SEMICONDUCTOR DEVICE WITH RESISTOR PATTERN AND METHOD OF FABRICATING THE SAME

Attorney Docket No. 4591-330/Application No. 10/675,336

Annotated Sheet Showing Changes

1/3
Fig. 1

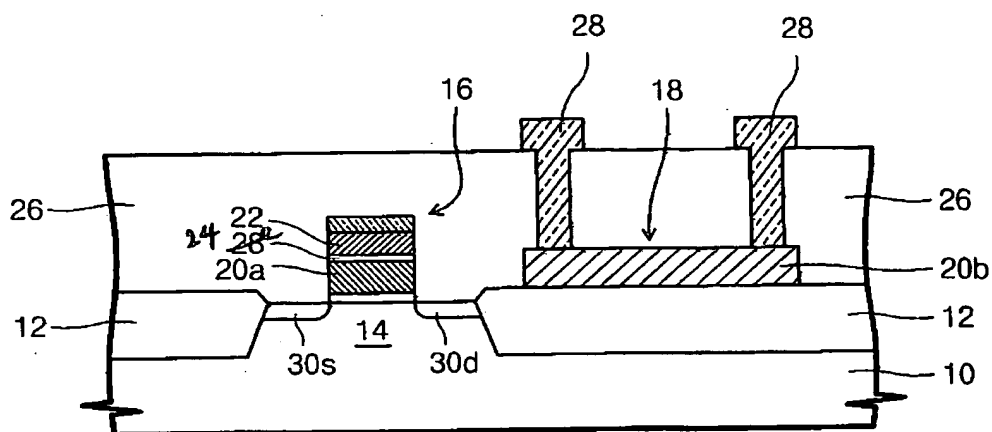
Please replace FIG. 1 with revised FIG. 1 to correct a drawing error, i.e., to replace the "28" representing the gate interlayer dielectric layer, which is the element between elements 20a and 22, with "24."

FIG. 1 is objected to as the same numeral "28" is used to represent two different elements therein.

FIG. 1 is amended to replace the "28" representing the gate interlayer dielectric layer, which is the element between elements 20a and 22, with "24". The accompanying text in the Specification is also amended. No new matter is added.
